SUBDIVISION STAFF REPORT Date: October 2, 2003

**NAME** Opus, Inc., C/O Crown Products

**LOCATION** 3107 Halls Mill Road

REQUEST Rezoning from R-1 to B-3, Planning Approval, Subdivision

## SITE PLAN

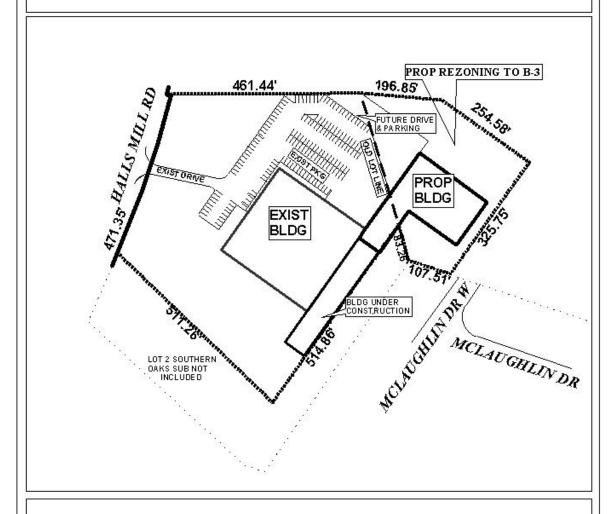
The flood zone information provided by the applicant is incorrect. FEMA designated Flood Zones AE, x-shaded and x-unshaded occur on this property and should be shown on the plat. The minimum finished floor requirement for structures on any lot that is located within the Floodway, Flood Zone AE and x-shaded should be shown on each lot. Must comply with all stormwater and flood control ordinances. Any work performed in the right of way will require a right of way permit.

Planning Approval is site plan specific, and while the exact parking layout is not illustrated, the extent of paving is illustrated; and Traffic Engineering and Urban Development staff could simply approve the circulation pattern.

Regarding the proposed subdivision, the site should be limited to the existing curb cut to Halls Mill Road.

**Subdivision:** The plat meets the minimum requirements of the Subdivision Regulations and is recommended for Tentative Approval subject to the following condition: 1) placement of a note on the final plat stating that the site is limited to one curb cut to Halls Mill Road, with the location and design to be approved by Traffic Engineering.
